REPORT TO INFRASTRUCTURE SERVICES COMMITTEE – 28 JANUARY 2016

STONEHAVEN FLOOD PROTECTION SCHEME

Appendix 1 – Summary of Objections and Officer responses

Hydrology and Hydraulic Modelling Addendum A to Revision A

Figure 2.1: Effect on water levels from lowering rock armour

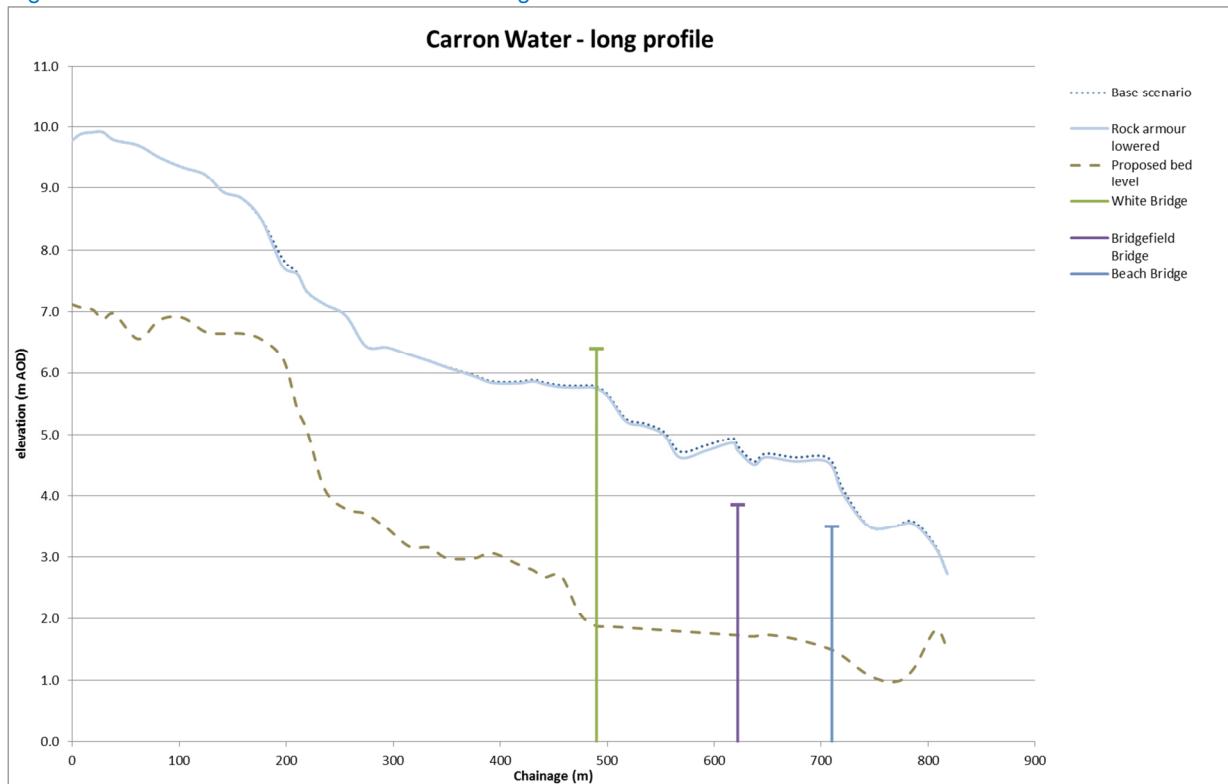
An opening in the rock armour was introduced, as displayed in Figure A.1 in Appendix A. The opening had a width of 12m (as the main channel) and a sill level of 3.5mAOD. The results (Figure 2.1) show that lowering the rock armour had little effect on flood water levels.

Figure 2.2: Effect on water levels from 2m widening downstream of Beach Bridge

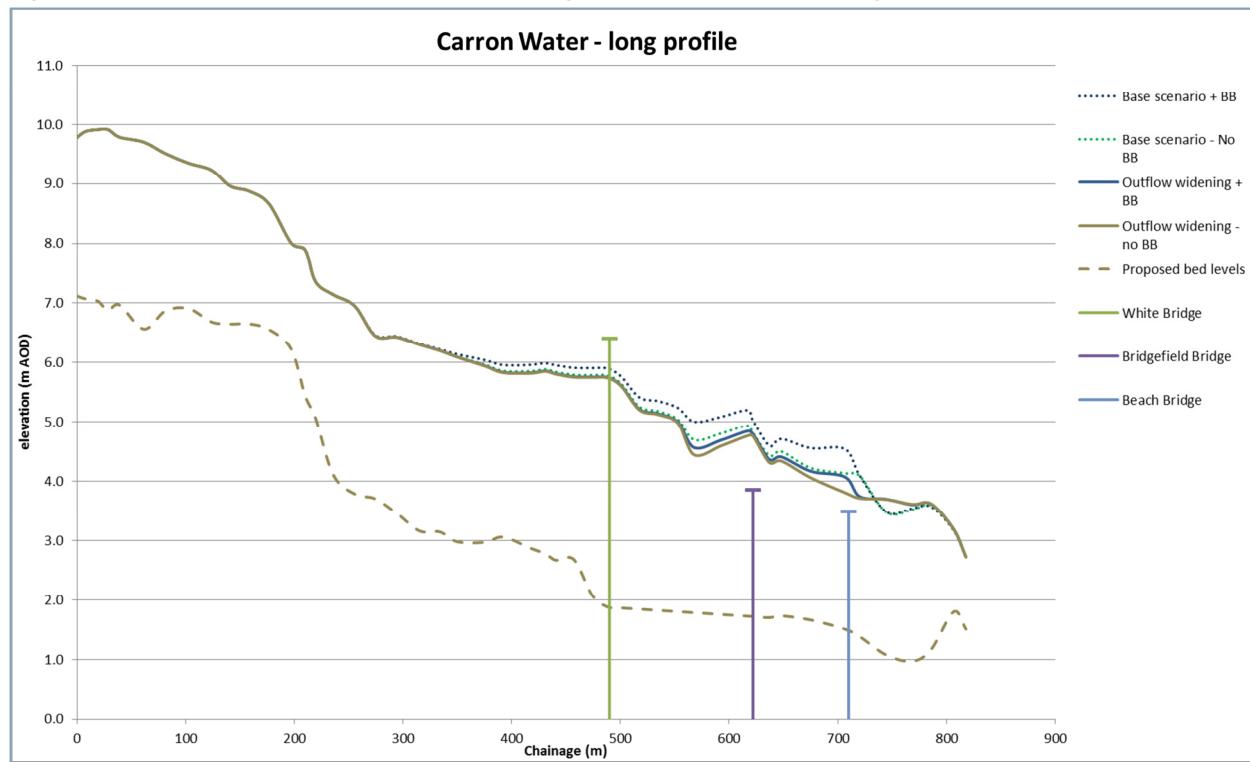
The channel downstream of Beach Bridge was widened by 2m, and assessed with both Beach Bridge raised and at its existing level as shown in Figure 2.2. The hydraulic modelling indicates that:

1. Widening the channel by 2m while keeping Beach Bridge ("Outflow widening + BB") has a similar effect to raising Beach Bridge without widening ("Base scenario - No BB").
2. If the channel is widened by 2m, the raising of Beach Bridge has little effect on flood water levels.
3. The 2m widening does not reduce flood water levels below the soffit level of the existing Bridgefield Bridge or Beach Bridge, so these bridges remain at risk.

Figure 2.4: Summary of Beach Bridge removal and outlet widening

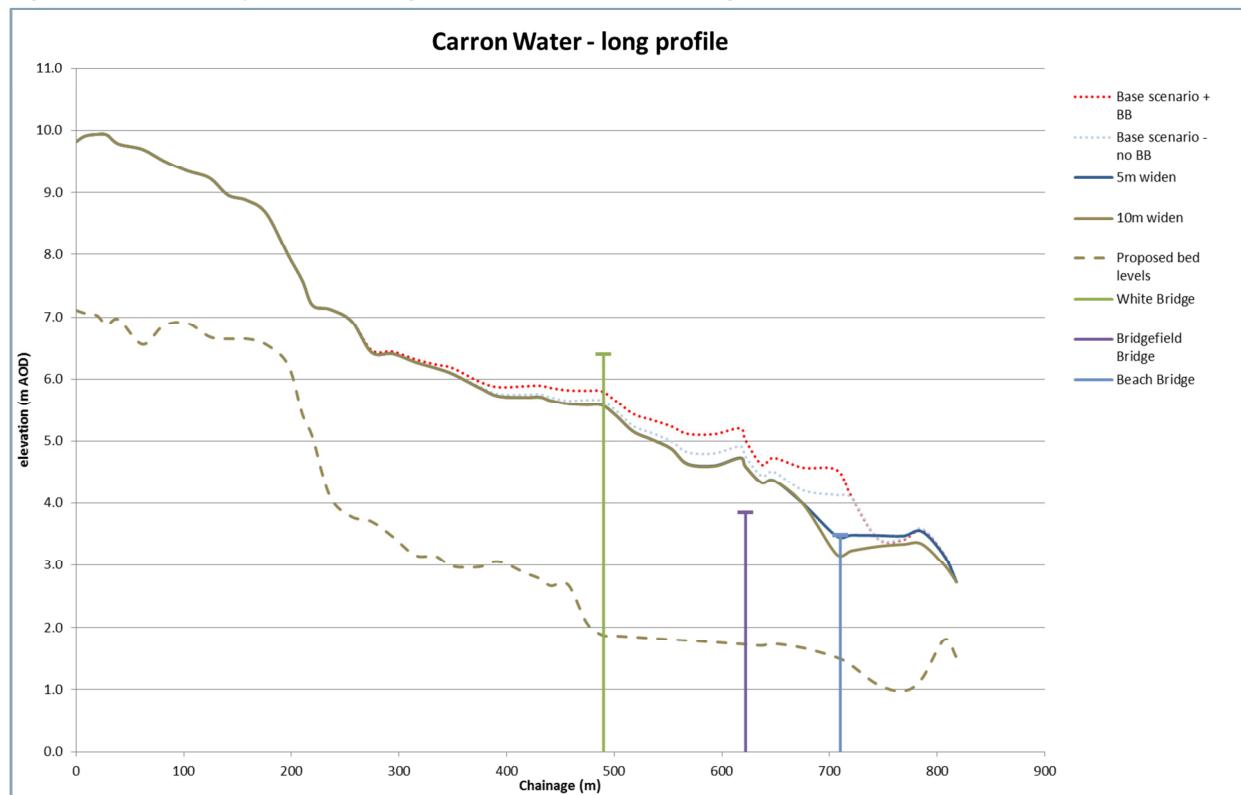
The channel downstream of Beach Bridge was widened by 5m and 10m, and assessed with both Beach Bridge raised and at its existing level as shown in Figure 2.4. The layout of the modelled scenarios are shown in Figure A.3 in Appendix A. The hydraulic modelling indicates that:

3. When compared to the flood water level of the proposed flood protection scheme with Beach Bridge raised (“Base scenario + no BB”), the reduction is limited to near Beach Bridge (0.85m) and Bridgefield Bridge (0.15m), however, when Beach Bridge is not raised (“Base scenario + BB”) the reduction is higher and also continues to further upstream of White Bridge.

4. For both the 5m and 10m widening, flood water levels are predicted to be below the soffit level of Beach Bridge, which means that potentially Beach Bridge could be retained in its existing position. However, the difference between the predicted flood water level and the soffit of the bridge would be less than the recommended freeboard value (0.6m).

Aberdeenshire Council have chosen to raise Beach Bridge in order to protect the pipe crossing. This addendum shows that widening of the rock armour downstream of Beach Bridge, in addition to raising Beach Beach, only shows localised improvements to flood water levels and so is not considered to provide a significant enough improvement to justify the additional widening works.

Figure 2.5: Effect on water levels from straightening the outlet channel

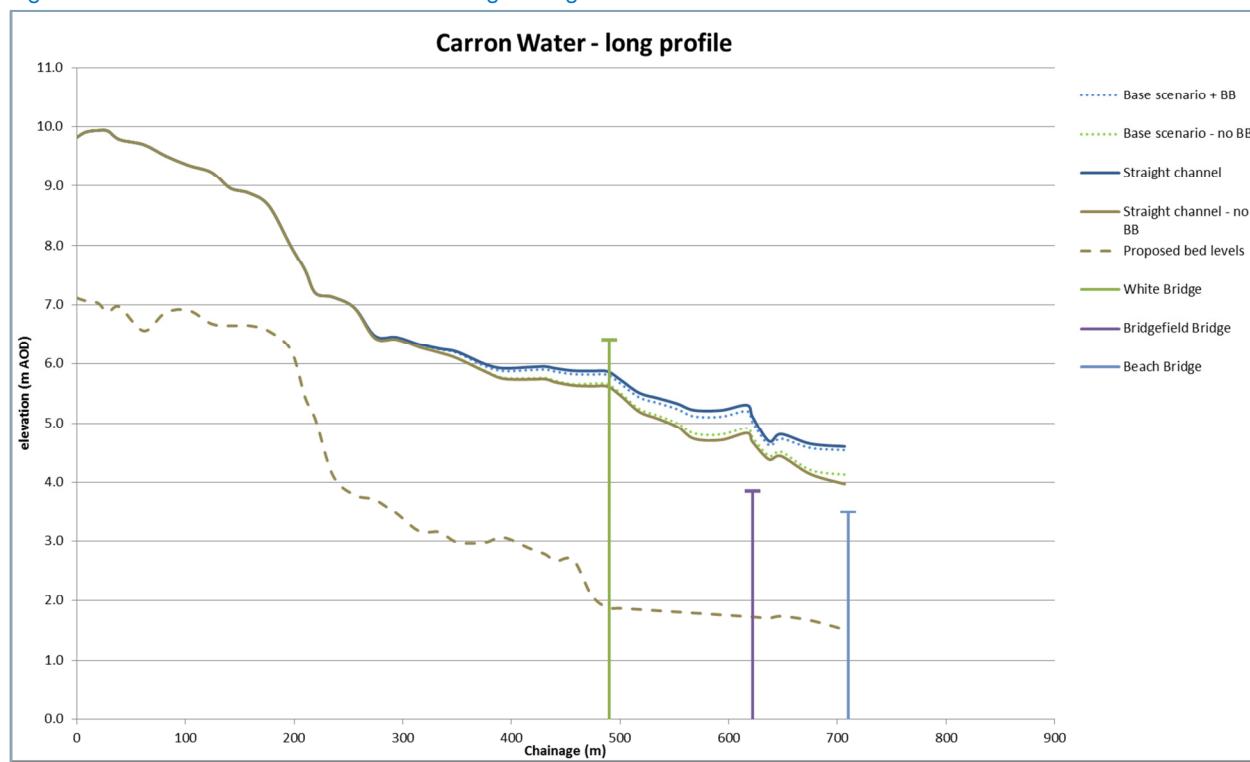
The effect of straightening the outlet to Carron Water downstream of Beach Bridge to the sea has been investigated. Figure A.2 in Appendix A shows the layout of the examined arrangement of the outlet.

The width of the channel was retained in line with the bottom section, i.e. 12m width. The bed level of the straightened channel has set at a peak level of approximately 1.6m AOD, similar to the average level of the bed upstream. The hydraulic modelling results shown in Figure 2.5 indicate that straightening the channel had little effect on flood water levels in the upstream channel.

It is noted that there is a Scottish Water pipe running along the coastline in this location with an elevation of approximately 1.8m AOD. The potential effect of the pipe on the flood water levels was assessed in the hydraulic model, which indicated that there will be no significant effect on flood water levels from lowering the pipe.
